17 December 2014

**RE: 23-39 ABBOTSFORD ROAD, BOWEN HILLS
TRAFFIC ENGINEERING ASSESSMENT**

This letter has been prepared in response to items 21, 22 and 23 of the Economic Development Queensland (EDQ) Decision Notice (DN) DEV2012/397. The proposed development comprises a 156 unit residential development at 23-39 Abbotsford Road and 28 Cintra Road, Bowen Hills.

Figure 1: B99 INGRESS MANOEUVRE

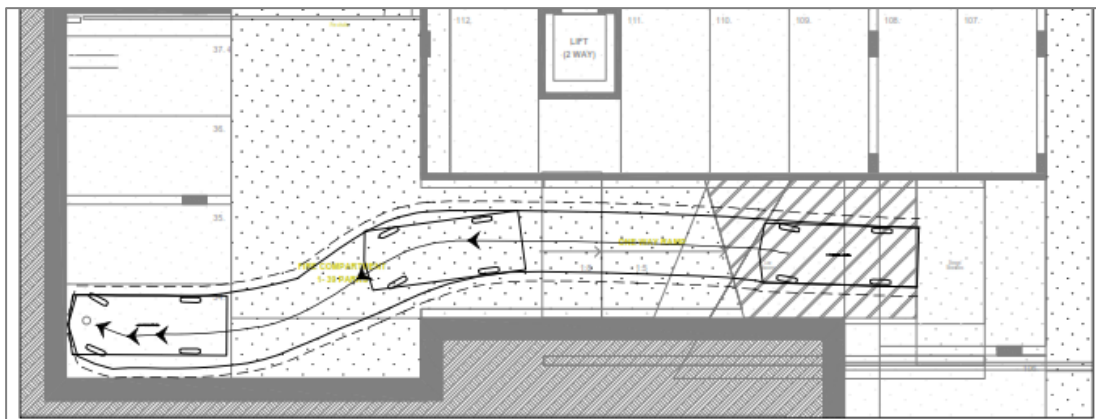
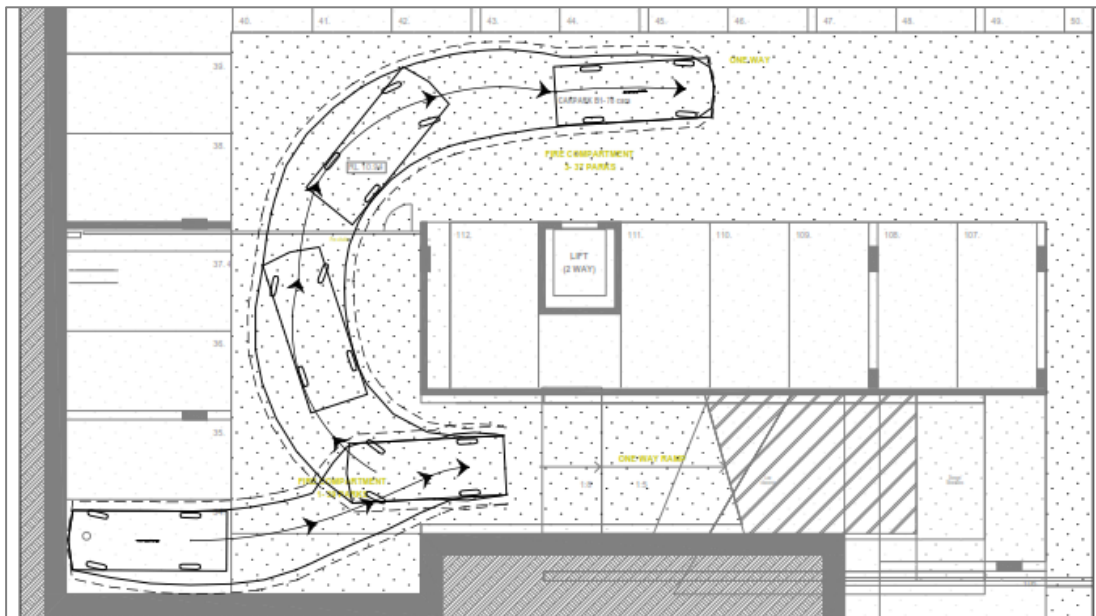
ITEM 5

A swept path assessment of a B99 car entering and exiting the nominated parking space was conducted in response to Item 5 of EDQ's FIL. Figures 1 and 2 demonstrate that a B99 car can enter and exit the parking space with sufficient clearances on both sides.

Figure 4: SECURITY GATE LOCATION - ENTRY

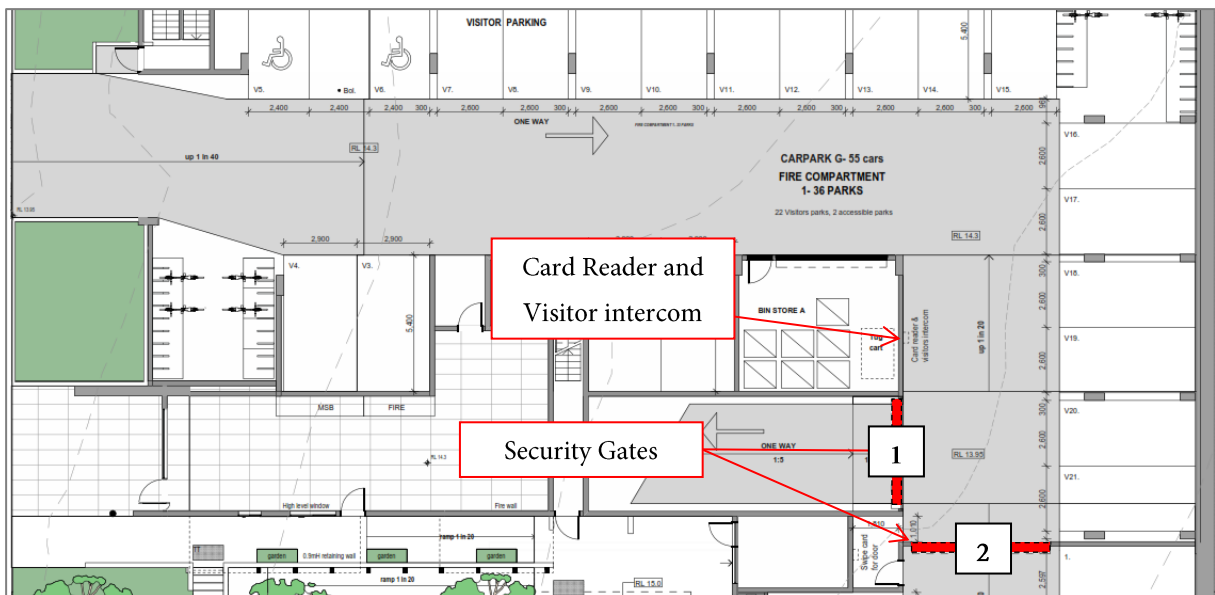
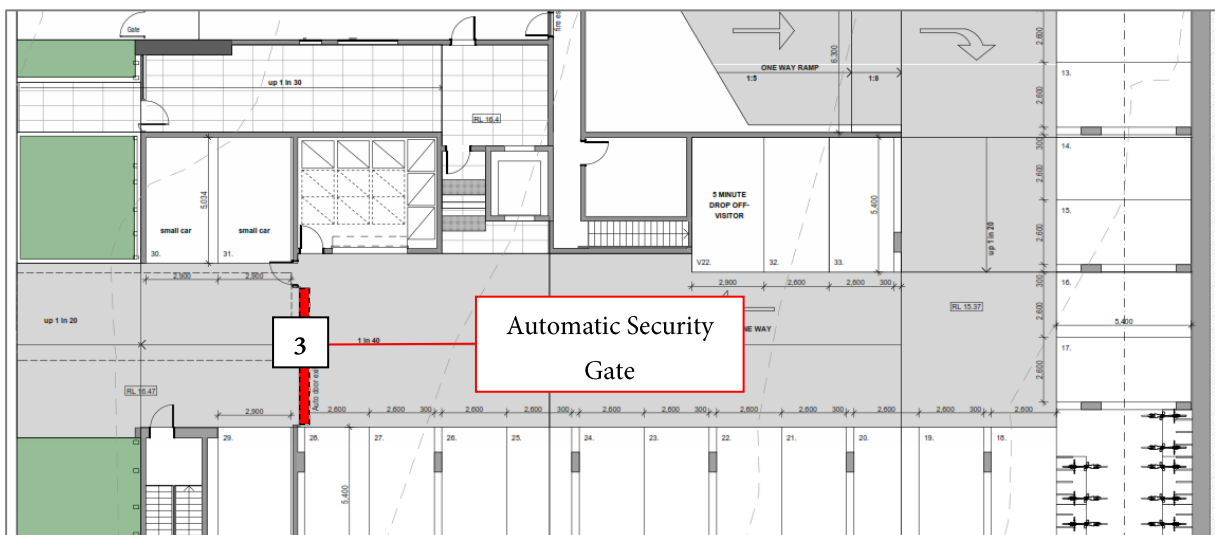
ITEM 9

The proposed location of security gates are shown in Figures 4 and 5. As this is a one-way car park system visitors to the site will need to pass through the security Gates 2 and 3 to exit the site. It is understood that visitors will use intercom to contact building management who will then open Gate 2 to allow the vehicle to exit, Gate 3 is an automatic gate which opens once a vehicle passes over a sensor imbedded in the pavement.

Figure 7: TURN BAY REQUIREMENT

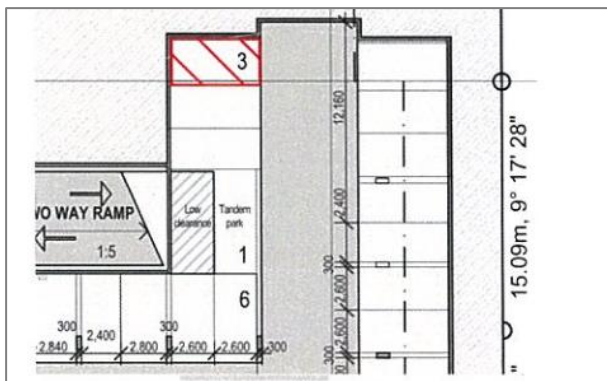
Item 12 of the EDQ FIL requires a turnaround bay to be installed, as shown in Figure 7. This requirement is considered to be unnecessary as all the car parking spaces are allocated to particular units. Therefore, any vehicle that enters this parking aisle would have an allocated parking space and the need for a turnaround bay is not warranted.

Figure 8: RELOCATED DOOR

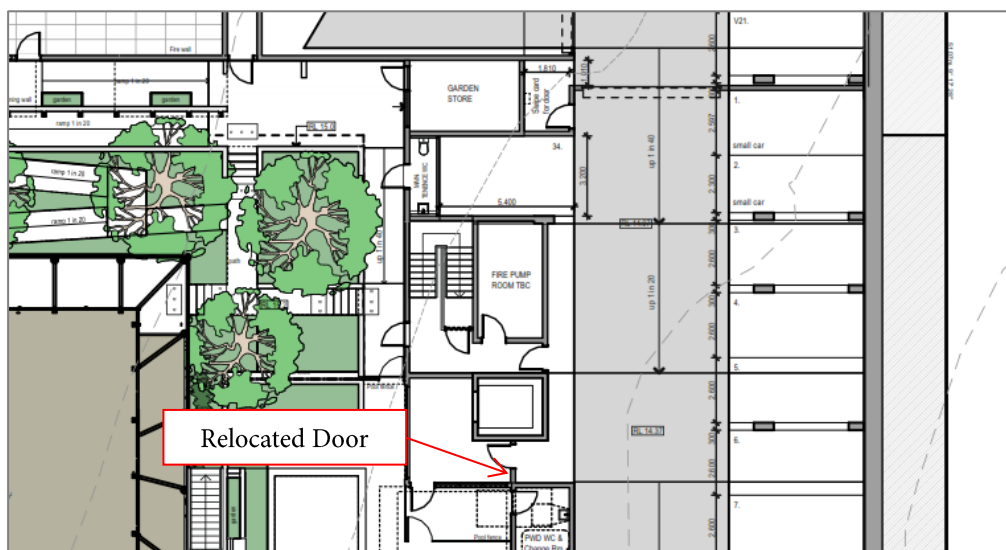
In accordance with item 13 of the FIL, the door has been re-located towards the lift to increase the available pedestrian walking area, as shown in Figure 8.
